Re: Comments on Report for HDD PA-WM1-0088.0000-RR

Comments on HDD PA-WM1-0088.0000-RR

(Photo generated from www.fractracker.org/2016/12/me2-schools-populations/)

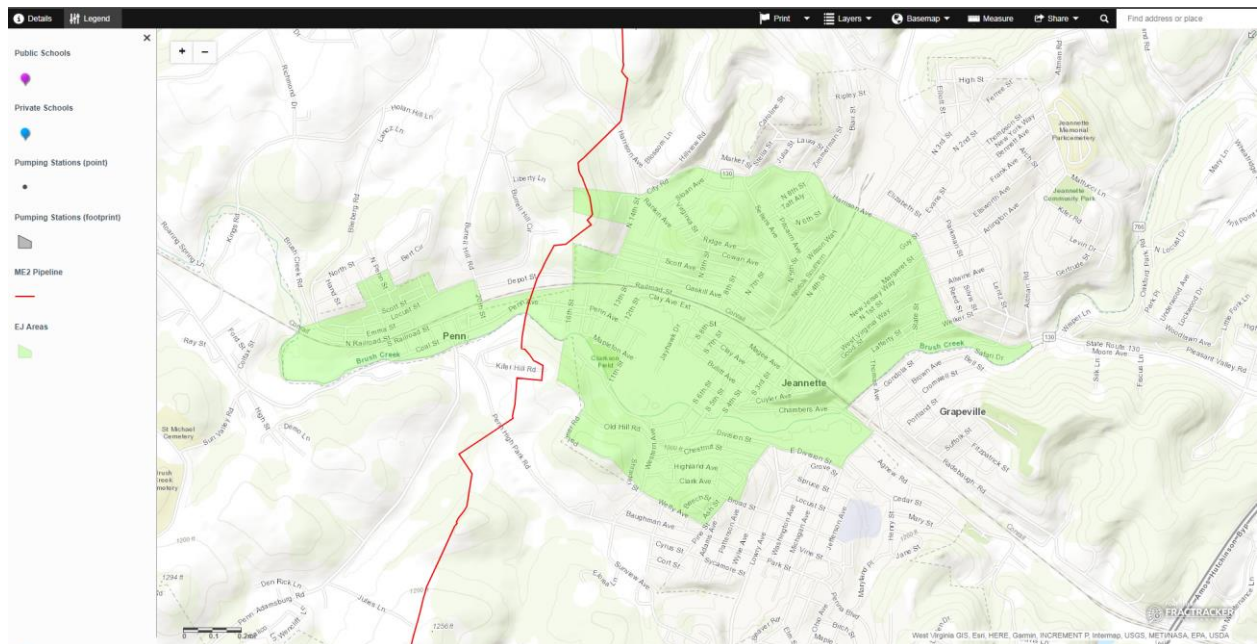
It is particularly critical that the recommended door-to-door water supply survey be conducted and analyzed prior to drilling—not only because it was the formal recommendation within the Report—but also because the Site drills directly through a designated Environmental Justice (EJ) area.

EJ areas are designated, in part, because the federal and Pennsylvania governments acknowledge that environmental harms disproportionately occur in communities with high concentrations of low-income and minority households. In response to this systemic inequality, the Commonwealth created the Office of Environmental Justice (OEJ). One of the contributing factors to an Environmental Justice area’s continual inequality is the residents’ inability to access information about projects carried out by state agencies that have the potential to create pollution. One of the goals of OEJ is to increase participation and communication in designated EJ areas.

According to the EPA’s database for Environmental Justice Screening and Mapping, 71% of the population living in the area crossed by the drill plan is considered low-income.⁵ U.S. Census data further reveals that the median household income for the area is \$27,017, markedly lower than the nation-wide median of roughly \$57,000.⁶ Low-income households may be more likely
